## Accessibility Audit

Church Hill Nursery School & Children's  
Centre  
47 Woodbury Road  
London  
E17 9SB

Date 10/12/2013

Appendix 2

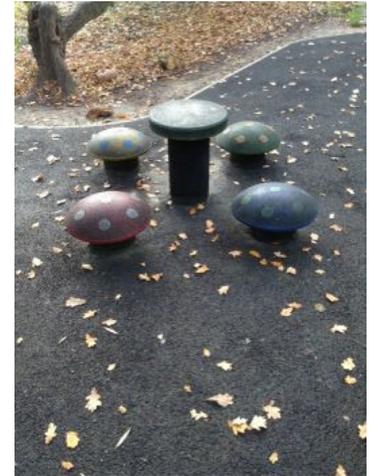
Question	Response	Details
1.5 - Is the location of the school clearly identified from the street? Visual clues and sufficient landmarks to aid orientation?	Yes	The Church Hill Nursery School and Children's Centre signage is in upper and lower case lettering which is the preferred format.
<div data-bbox="150 316 463 632" data-label="Image"> </div> <div data-bbox="246 635 362 662" data-label="Caption"> <p>Appendix 2</p> </div>

Appendix 42

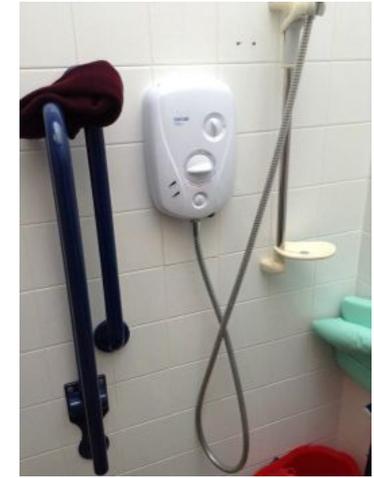
Question	Response	Details
12.4 - Compartment door controls all easily gripped and operated? Are cubicle doors suitably colour contrasted against the panels?	No	One of the WCs - The door control is not easy to use for those with dexterity impairments.
 <p data-bbox="248 675 367 699">Appendix 40</p>		
12.5 - Are urinals well contrasted and do they have grab rails to assist people with ambulant disabilities?	N/A	
12.6 - Are lever style taps provided within the WCs to aid people with dexterity impairments?	Yes	Throughout the WCs, lever taps are provided which are easy to use for people with dexterity impairments.
   <p data-bbox="248 1265 367 1289">Appendix 41</p> <p data-bbox="568 1265 687 1289">Appendix 42</p> <p data-bbox="889 1265 1008 1289">Appendix 43</p>		
12.7 - When there is no accessible WC available, is there a facility provided for people with ambulant disabilities?	N/A

Appendix 45

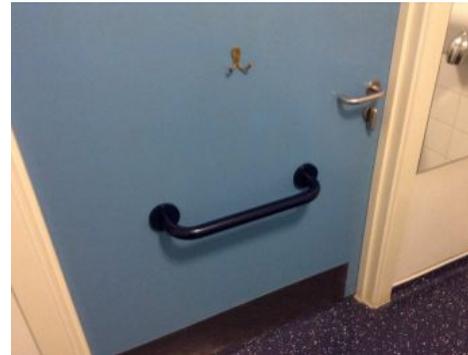
Question	Response	Details
<p>13.4 - Hand washing and dry facilities within easy reach of someone seated on WC? Is the hand basin suitably positioned in accordance to BS8300?</p>	<p>No</p>	<p>Near Reception accessible WC - The hand wash basin is not within easy reach whilst seated on the toilet pan. There is a hand dryer provided to aid people who may struggle to use hand towels however this is not colour contrasted against the background to aid people with impaired vision.</p> <p>Nursery School accessible WC - The hand wash basin is within easy reach whilst seated on the toilet pan. There is a hand dryer provided to aid people who may struggle to use hand towels however this is not colour contrasted against the background to aid people with impaired vision.</p>
<div style="display: flex; justify-content: space-around;"> <div style="text-align: center;">  <p>Appendix 45</p> </div> <div style="text-align: center;">  <p>Appendix 46</p> </div> </div>

13.4B	Near Reception accessible WC - There is a hand dryer provided to aid people who may struggle to use hand towels however this is not colour contrasted against the background to aid people with impaired vision.  Nursery School accessible WC - There is a hand dryer provided to aid people who may struggle to use hand towels however this is not colour contrasted against the background to aid people with impaired vision.	Add colour contrast to the hand dryer so it can be seen against the background.	<b>OG</b>

Appendix 47

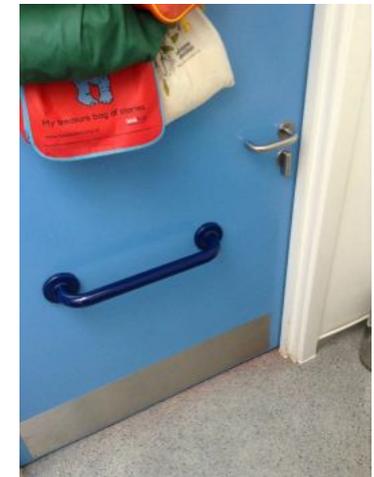
Question	Response	Details
13.5 - Door controls, lock and light switch easily reached and operated? Is there a grab rail to the inner face of the entrance?	Yes	Both accessible WCs - Grab rail on the door is provided. There is a lever lock that is easy to use for those with dexterity impairments. Sensor lighting is provided.
 <p>Appendix 47</p>  <p>Appendix 48</p>		
13.6 - Tap appropriate for use by a person with limited dexterity, grip or strength?	Yes	Both accessible WCs have lever taps to aid people with dexterity impairments.
 <p>Appendix 49</p>  <p>Appendix 50</p>
